Eliza Yard – Jersey Street Ancoats

S96a - Design Changes

June 2025

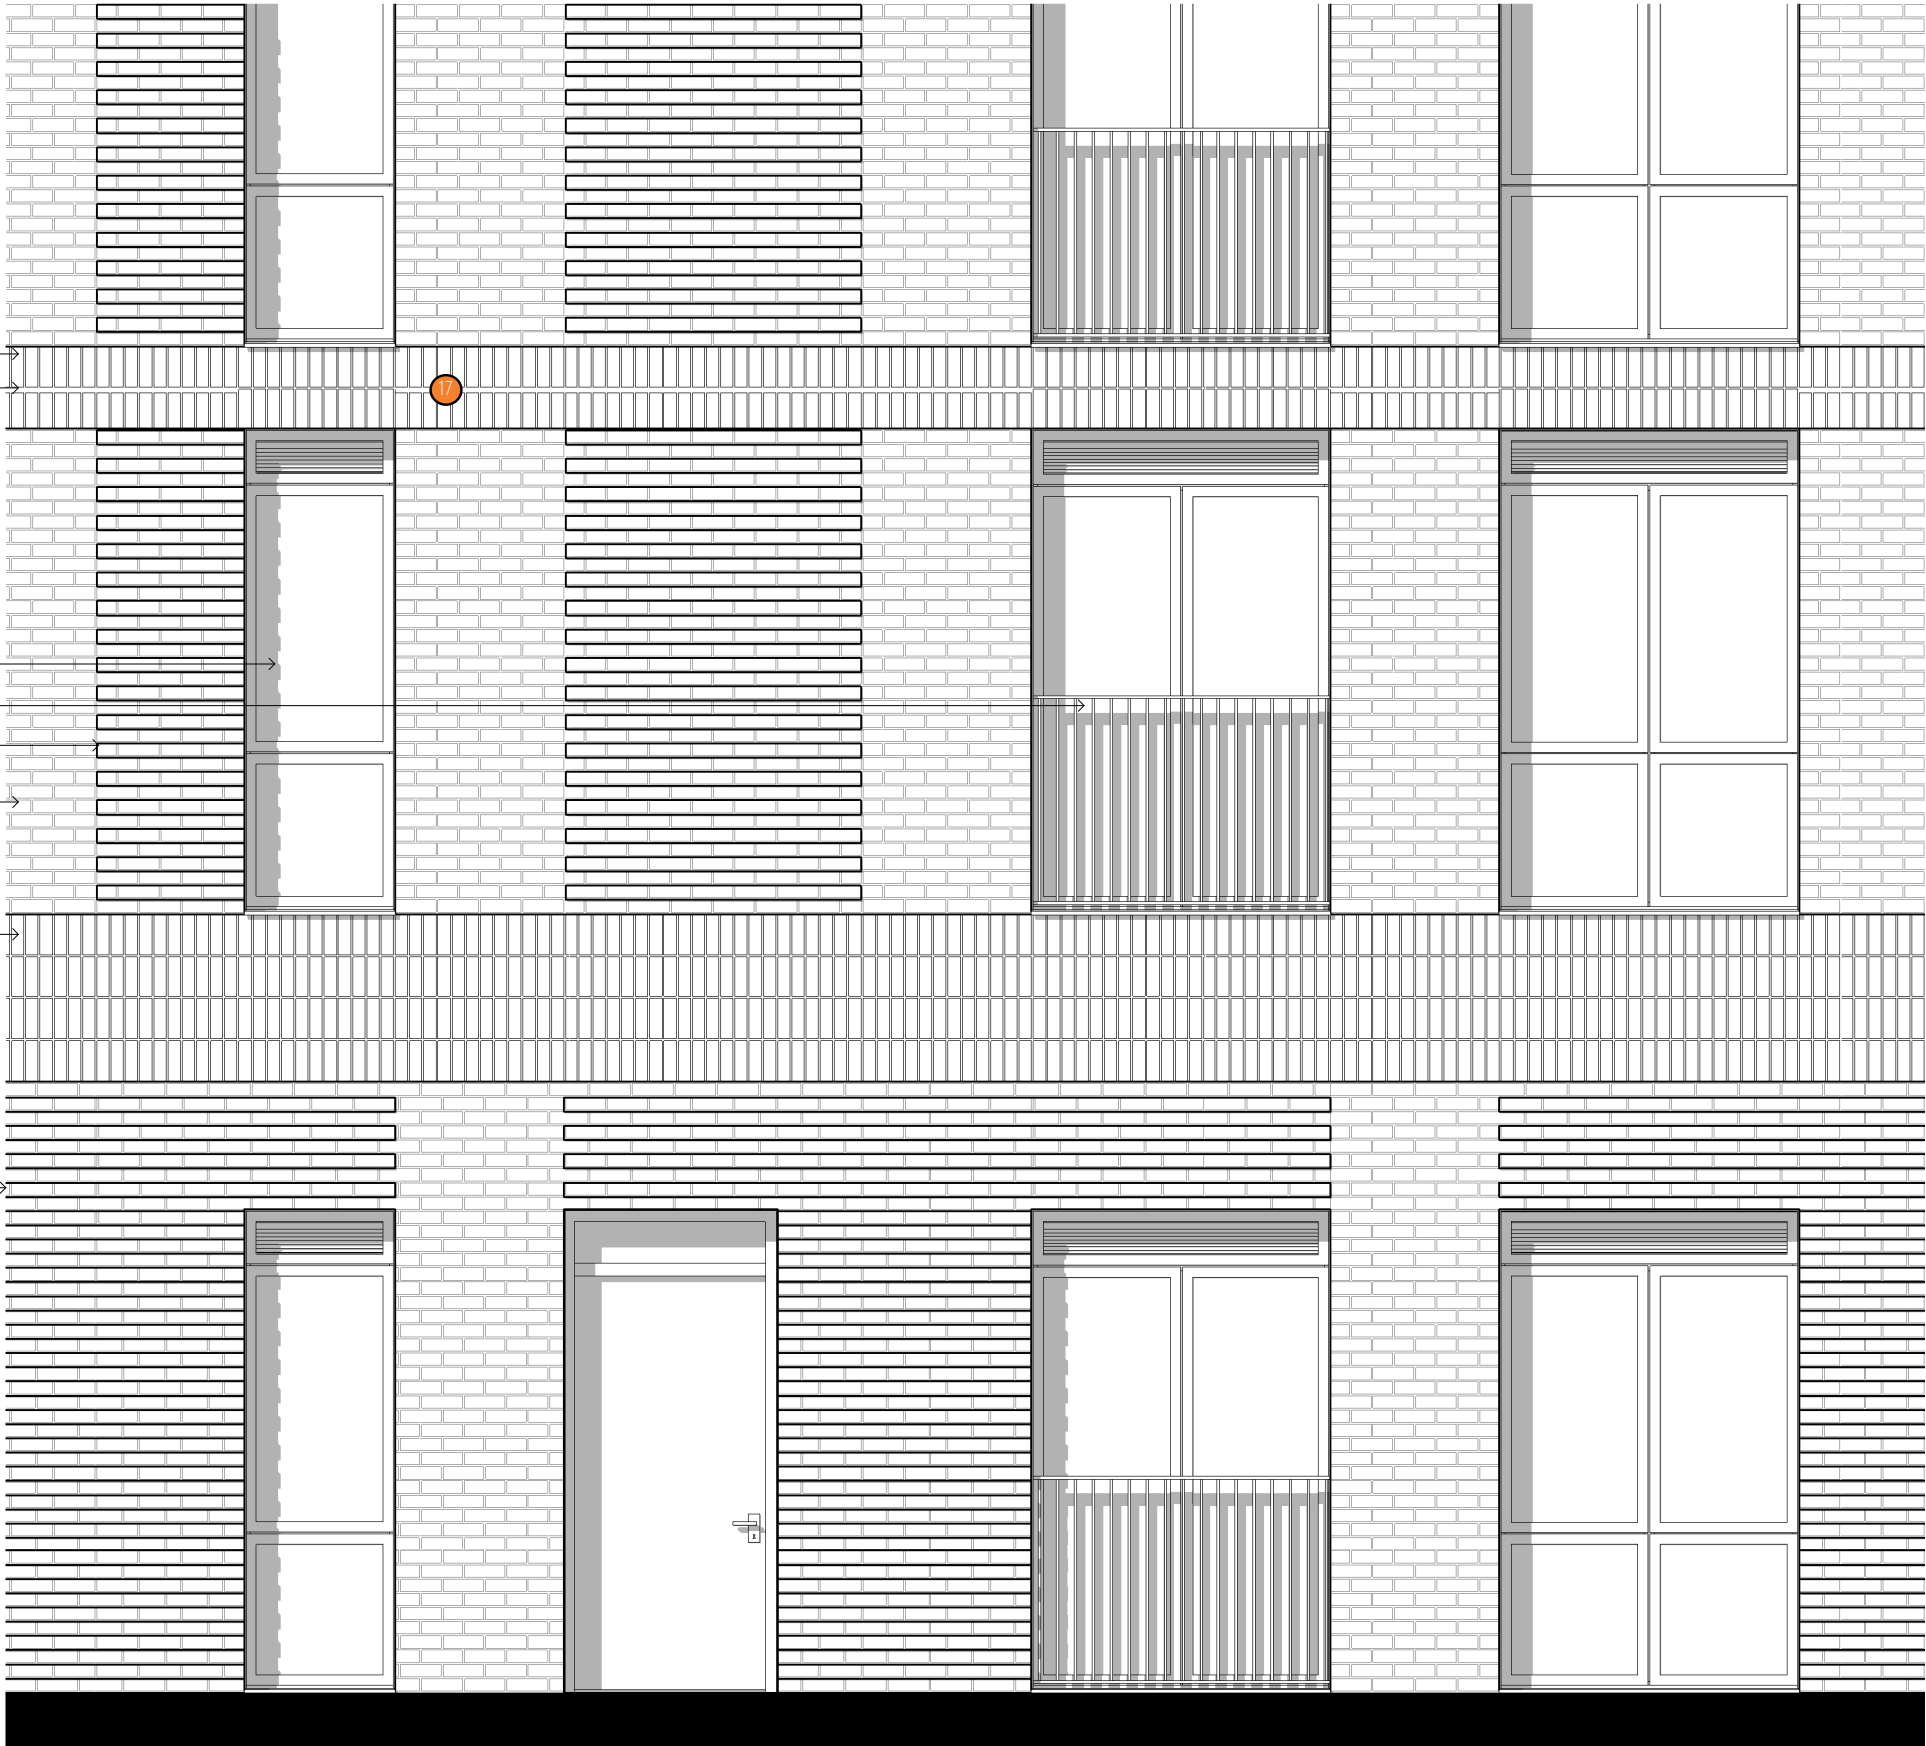
- 6 Bottom pane in windows (WT.K) updated from back painted glass to clear glass to allow for more light into apartments and increase facade transparency. Refer to PRP drawing EYJW-PRP-BC-ZZ-DR-A-021042-Bay Elevation and Section - Brick_P03 for further information.
- 9 Decorative perforated aluminium panels with triangular pattern have been added in front of the horizontal louvres above the curtain walling to visually screen the louvres. Refer to Page 9 of this document for further information.
- 10 Minor update to the design of the substation door to meet the requirements of the power utility provider.
- 11 Double door into commercial unit updated to single door. This is to comply with the clear width requirements of Part M of the building regulations.

Site Plan

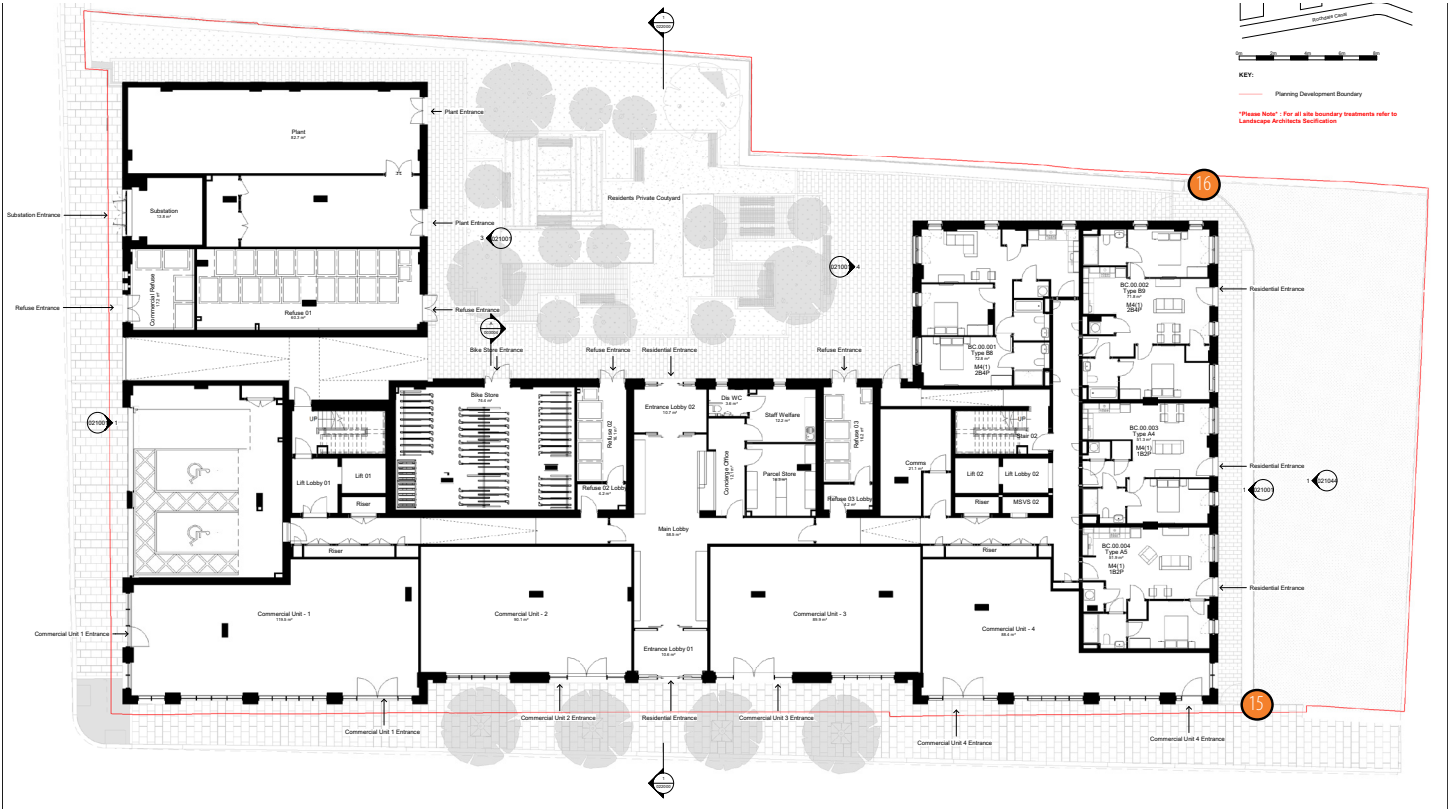
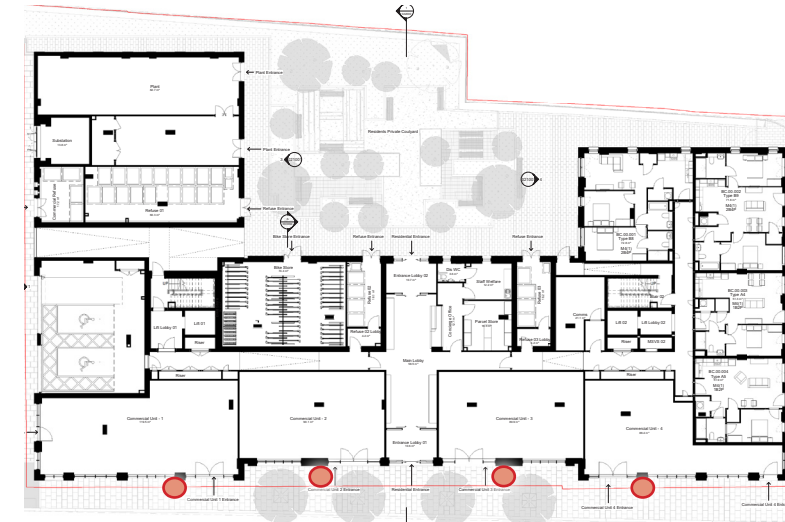
- 15 Single gate added on Jersey Street for improved boundary security.
- 16 Gate moved slightly to avoid opening in front of residential window.

PROPOSED PROJECTING SIGNAGE LOCATIONS

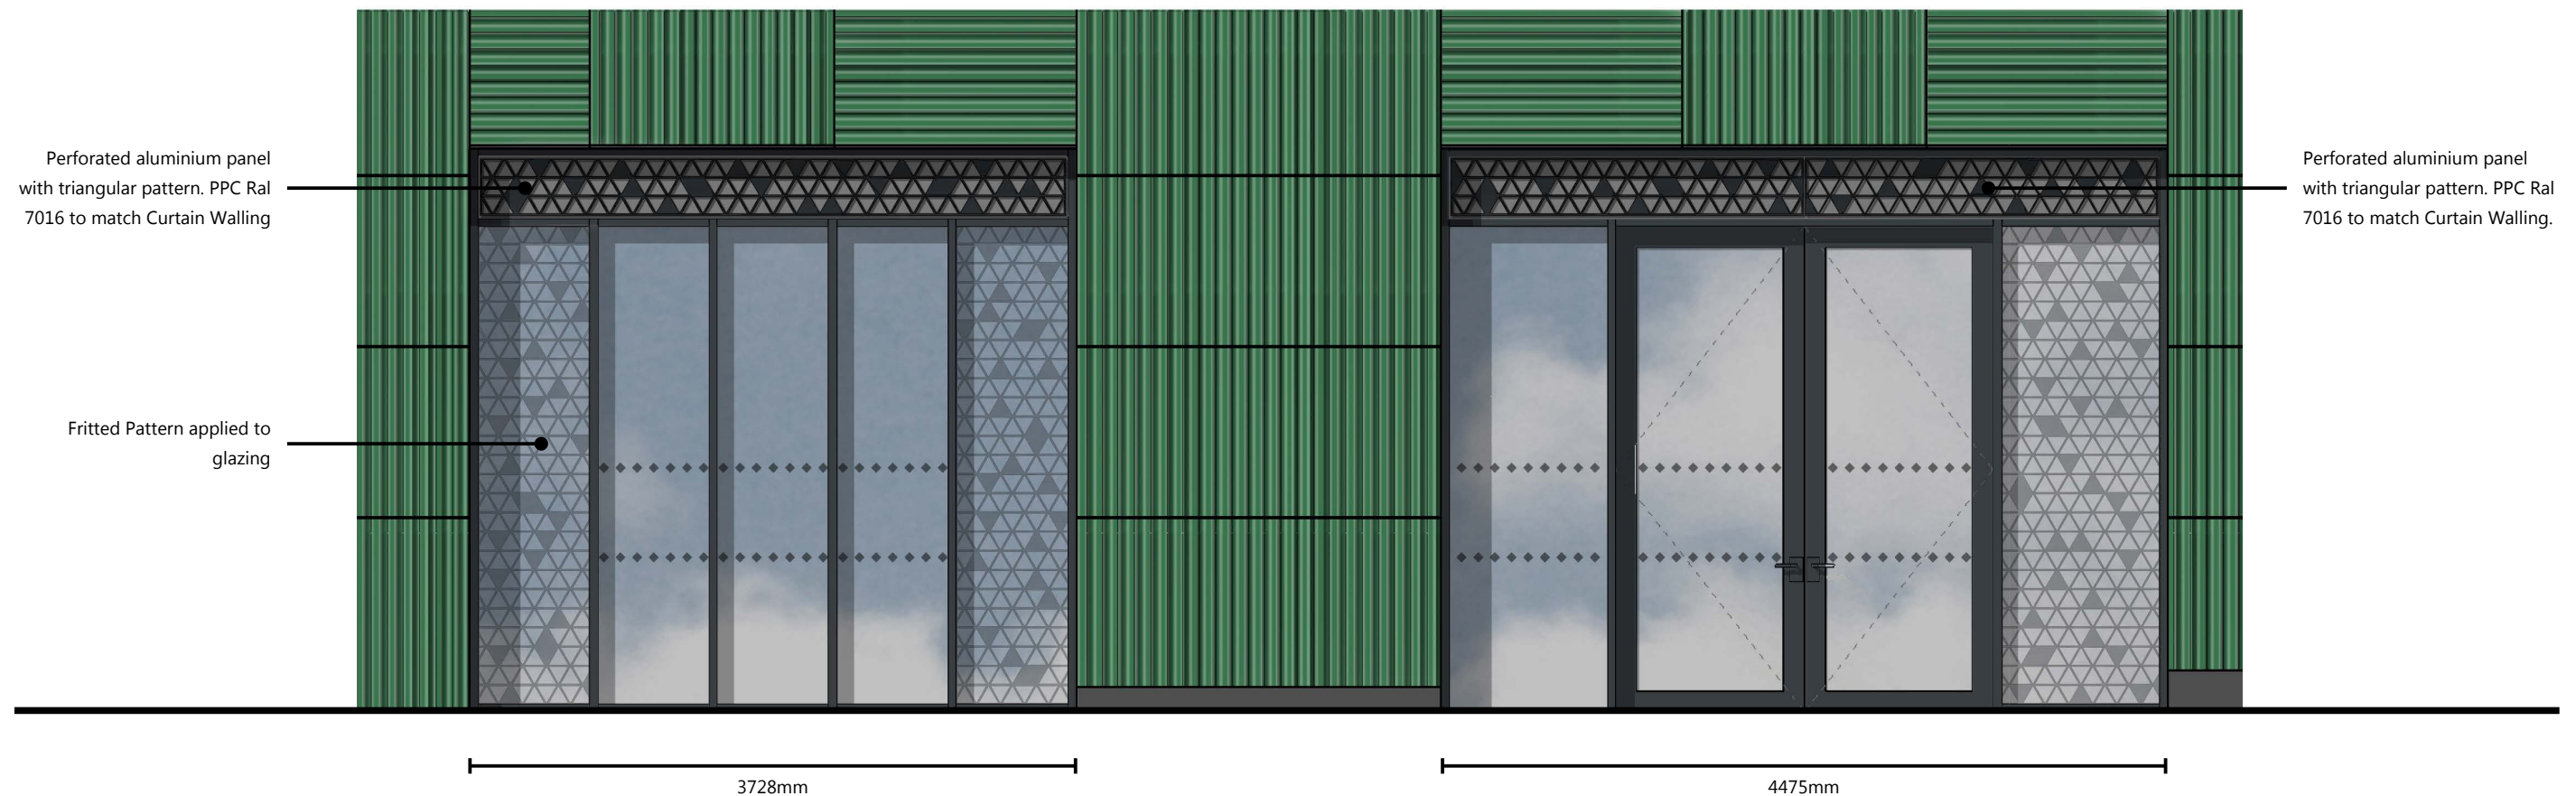
Commercial unit signage fixed to curtain walling has been replaced by projecting signage fixed to brickwork adjacent to commercial units. These signs will be made of an Internal Stainless steel sub frame with PPC Aluminium panels externally. The thickness of the sign will be 30mm as per Manchester City Council guidance.
